W3F1-2025-0032

Subject: Licensee Amendment Request – Technical Specification Section 5.0,  
"Design Features," Rewrite

Waterford Steam Electric Station, Unit 3  
NRC Docket No. 50-382  
Renewed Facility Operating License No. NPF-38

**Technical Specification Pages Markups**

FIGURE 5.1-1  
EXCLUSION AREA

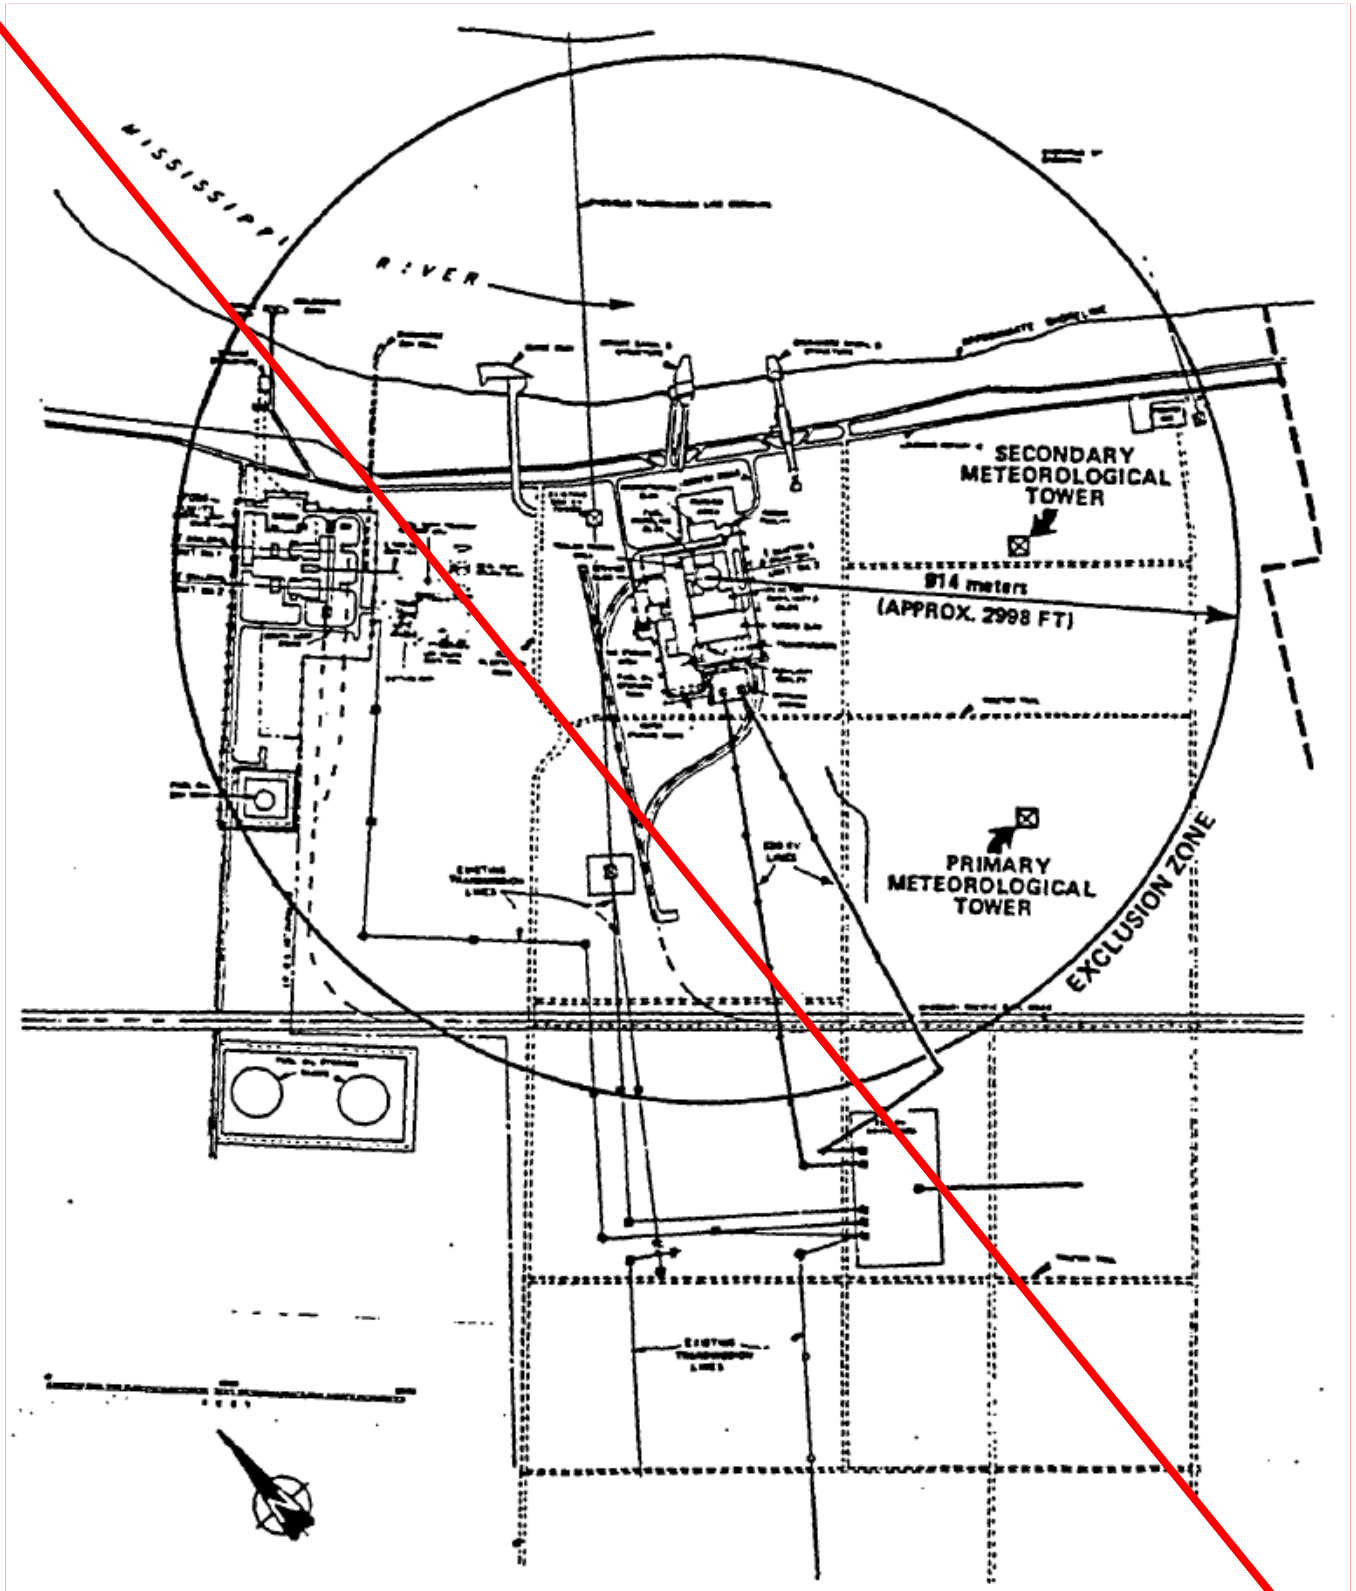
Also, WF3 TS 5.1.3 and Figure 5.1-3, associated with maps defining unrestricted areas for radioactive gaseous and liquid effluents, are proposed for removal from the TSs. This figure is currently located in Attachment 1 of the WF3 ODCM. In addition, the location of fuel handling building is shown on Figure 2-3 of the Emergency Plan and on Figure 2.1-4 of the WF3 Updated Final Safety Analysis Report (UFSAR). WF3 UFSAR Figure 2.1-4 also includes the location of the plant stack. In addition, WF3 TS 5.1.3 also describes, in part, a definition of the unrestricted area of the site, in order to address potential radioactive release to this area. The WF3 ODCM governs monitoring and measuring releases to unrestricted areas of the WF3 site and surrounding areas as defined in WF3 TS 1.16. WF3 ODCM Section 3.0 provides the definition of "unrestricted area" as it pertains to WF3. In addition, Chapters 11 and 12 of the WF3 UFSAR describe controls and limits on radioactive releases to unrestricted areas. Since changes to the Emergency Plan are subject to 10 CFR 50.54(q), ODCM changes are governed by WF3 TS 6.14, and UFSAR changes are subject to 10 CFR 50.59 requirements, any future changes to the information would be properly evaluated and adequately controlled. Furthermore, the deleted text and figure are not required to be included in the TS by 10 CFR 50.36(c)(4), and NUREG-1432 does not include this information in the Design Features section. Therefore, it is proposed that the discussion of a map defining unrestricted areas for radioactive gaseous and liquid effluents be deleted from the TSs, along with associated Figure 5.1-3.

~~5.1.1 The exclusion area shall be as shown in Figure 5.1-1.~~

The Waterford Steam Electric Station, Unit 3, is located on a 3,561.3 acre plot in Killona, Louisiana, in St. Charles Parish, about 25 miles (40 km) west of New Orleans. The exclusion area boundary shall have a radius of 914 meters from the center of the reactor.

FIGURE 5.1-2—LOW POPULATION ZONE

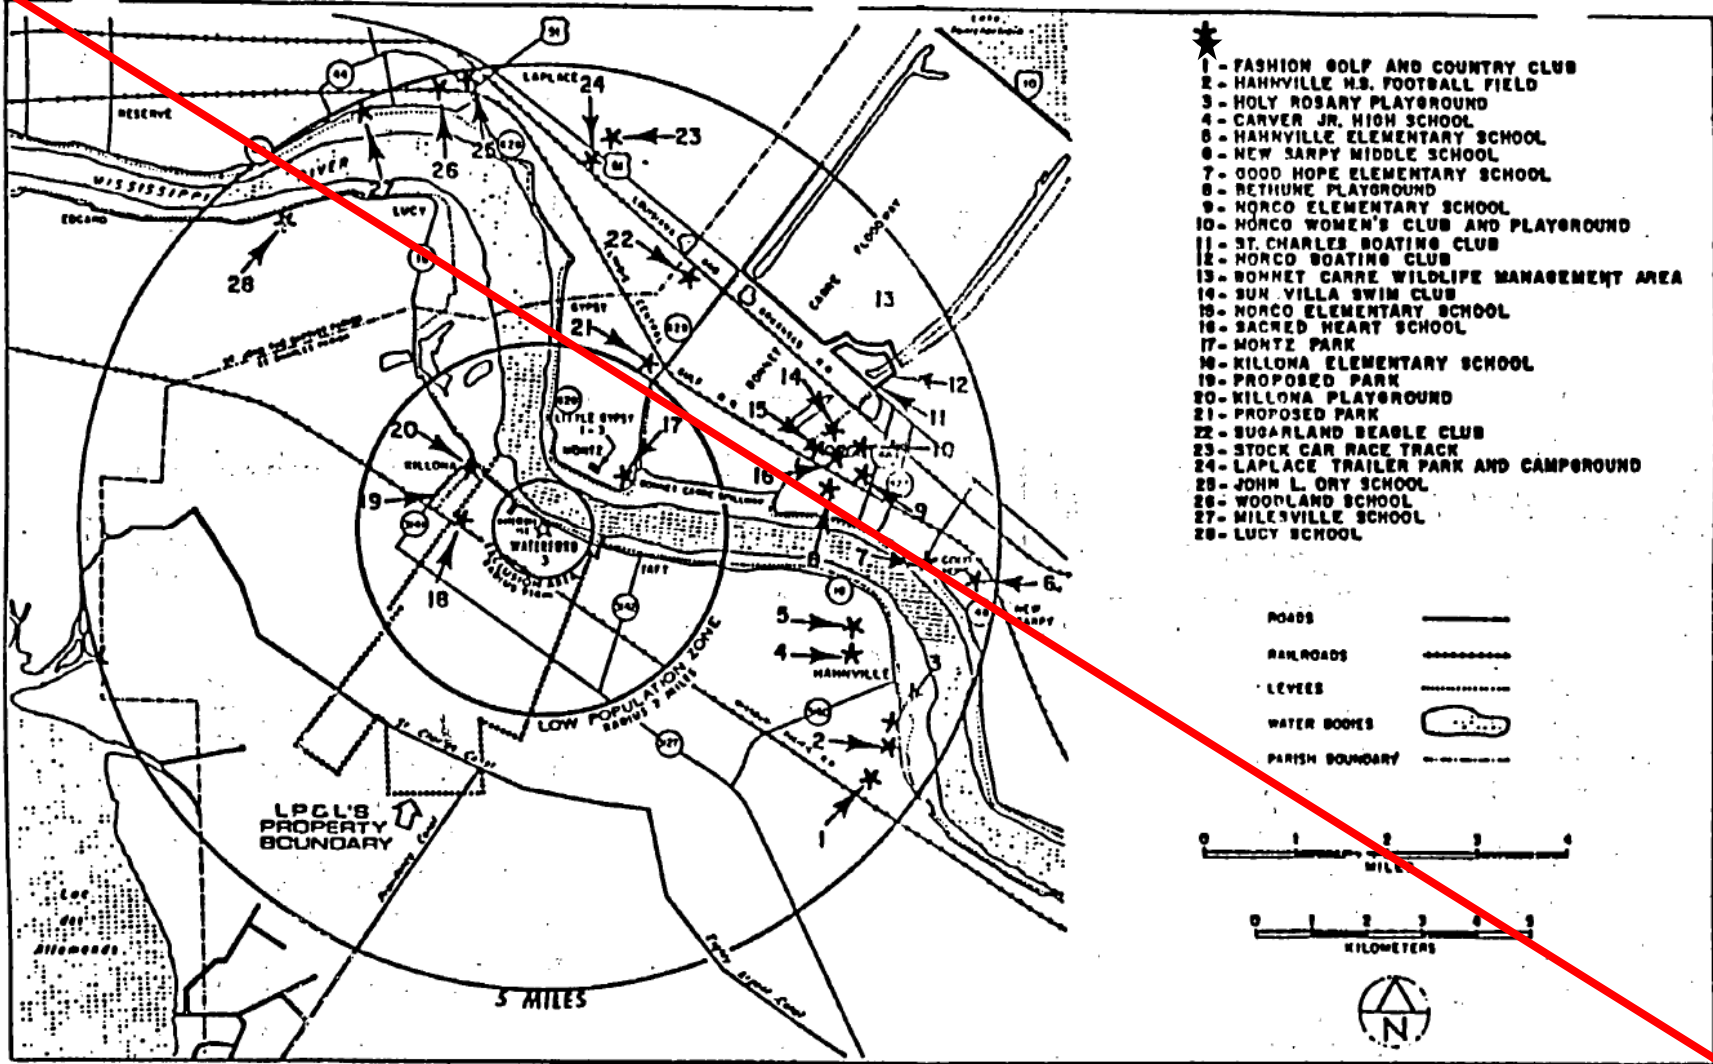
- WF3 TS 5.1, "Site Location", is revised to include a summary description, consistent with NUREG-1432 (Reference 1) and information currently contained in the WF3 Emergency Plan. This change removes TSs 5.1.1 and 5.1.2 along with Figures 5.1-1 and 5.1-2, associated with the WF3 Exclusion Area and LPZ, respectively. Exclusion Area and LPZ figures (maps) are currently contained in WF3 Emergency Plan, Figure 2-1 and Figure 2-8.
- WF3 TS 5.1.3 and Figure 5.1-3, associated with maps defining unrestricted areas for radioactive gaseous and liquid effluents, are removed. This figure is currently located in Attachment 1 of the WF3 ODCM. In addition, the location of fuel handling building is shown on Figure 2-3 of the Emergency Plan and Figure 2.1-4 of the WF3 Updated Final Safety Analysis Report (UFSAR). WF3 UFSAR Figure 2.1-4 also includes the location of the plant stack.

~~5.1.2 The low population zone shall be as shown in Figure 5.1-2.~~

FIGURE 5.1.3 SITE BOUNDARY FOR RADIOACTIVE GASEOUS AND LIQUID EFFLUENTS

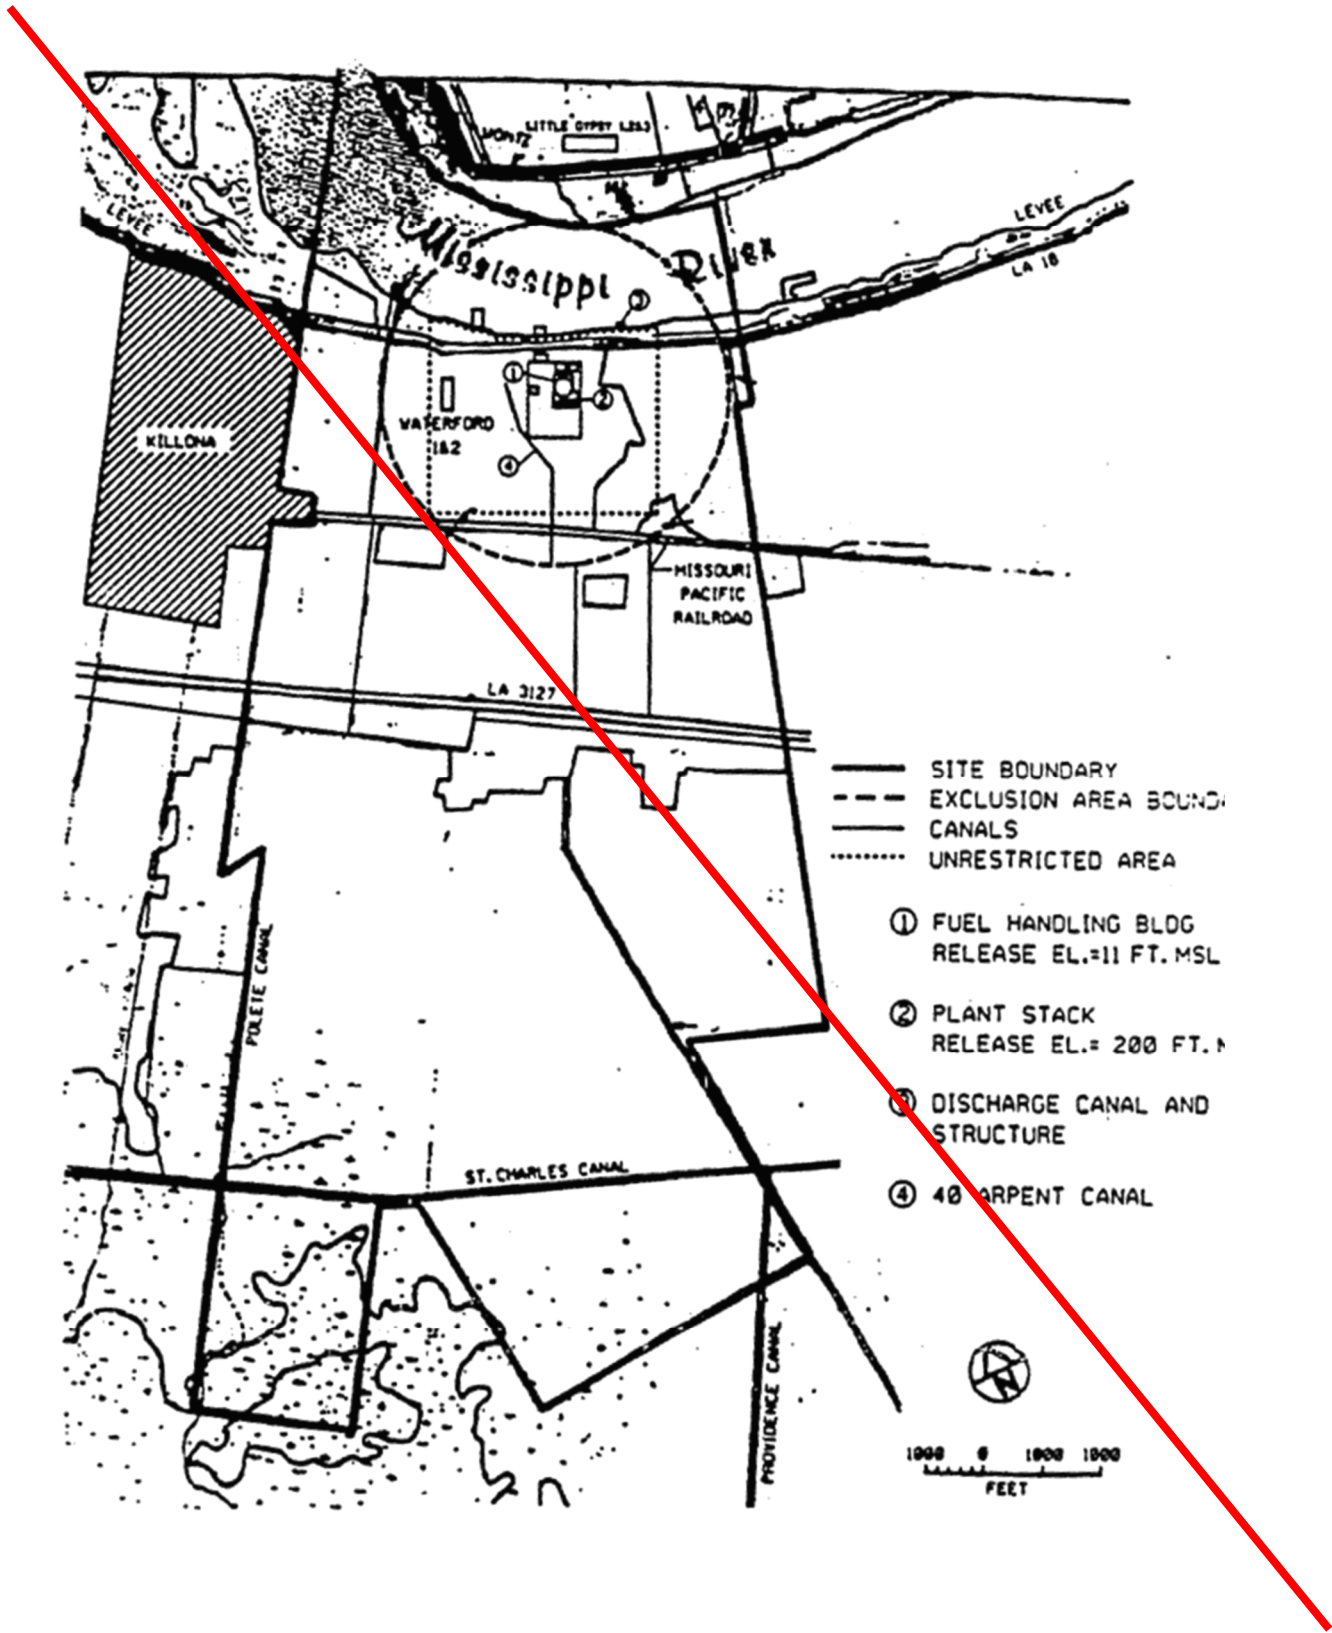
~~5.1.3 Information regarding radioactive gaseous and liquid effluents, which will allow identification of structures and release points as well as definition of UNRESTRICTED AREAS within the SITE BOUNDARY that are accessible to MEMBERS OF THE PUBLIC, shall be as shown in Figure 5.1-3.~~
